TOWN OF HORIZON CITY
Planning and Zoning Commission Staff Report

Case No.: SDP25-0002 Verdancia Unit 2 Preliminary

Application Type: Preliminary Subdivision Plat Application
P&Z Hearing Date: April 21, 2025
Staff Contact: Art Rubio, Chief Planner
915-852-1046, Ext. 407; arubio@horizoncity.org

NOTE:
1. COMMON OPEN SPACE (C.O.S.) LANDSCAPE, SIDEWALK & LANDSCAPE MEDIAN
WILL BE MAINTAINED BY THE HOA.
2. LANDSCAPING OF TRAIL WITHIN R.O.W. AND COMMON OPEN SPACE.
PROPOSED TYPICAL 54' ROW STREET WITH C.O.S. TRAIL SECTION DETAIL
(RESIDENTIAL SUB-COLLECTOR)
SCALE: N.T.S.

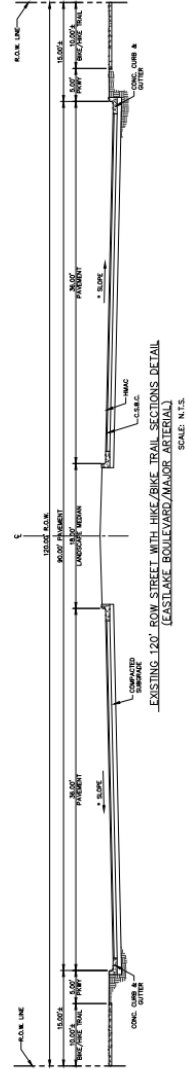
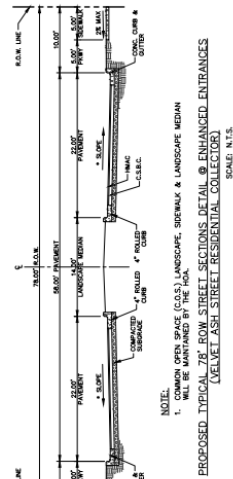
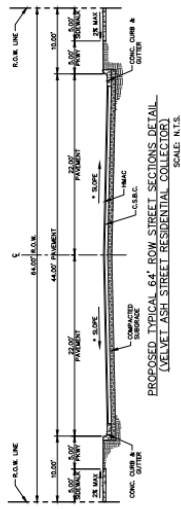
1. Modification from a 52-ft residential sub-collector street right-of-way to a 54-ft street right-of-way at all local residential sub-collector streets. The 54-ft street right-of-way will consist of two 5-ft parkways, two 5-ft wide concrete sidewalks and a 34-ft wide pavement structure with curb & gutter.

2. Modification to use a 54-ft street right-of-way with meandering trails at all local residential sub-collector streets abutting common open space lots. The 54-ft street right-of-way will consist of two 5-ft parkways, 34-ft wide pavement structure with curb & gutter and two 8-ft wide meandering trails. The 8-ft trails will meander within the street right-of-way parkway area and the adjacent 15-ft common open space landscape lot. This will provide a visually appealing and safe walking trail along this corridor. Landscape areas will be maintained by the HOA.
